EZ Hauler 3500/3800 Product Announcement

Subject: Outrigger Gusset Update

Announcement: CCG1651

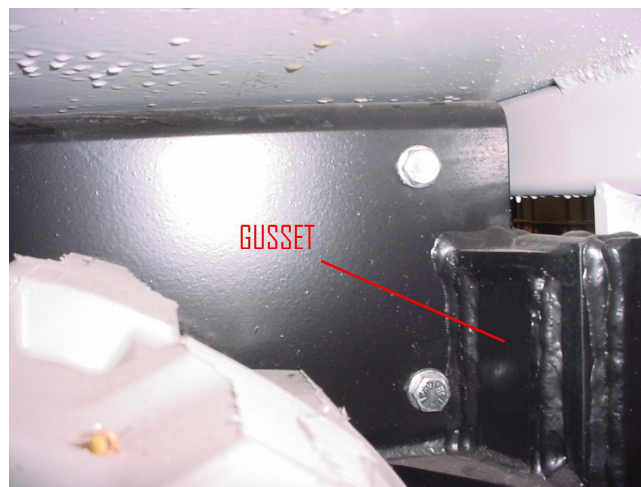
EZ Hauler models 3500/3800 manufactured prior to June 1, 2006 may experience hydraulic outrigger structural damage when overloaded. Failure to update could result in total outrigger failure!

This mandatory update includes that gussets be welded in the backs of the outrigger body mounting plates on both the front and back of the unit. If you do not have this update, then you must call SDP Manufacturing, Inc., then they will supply you with the materials needed. The gussets will need welded in, so a qualified welder must do this work.
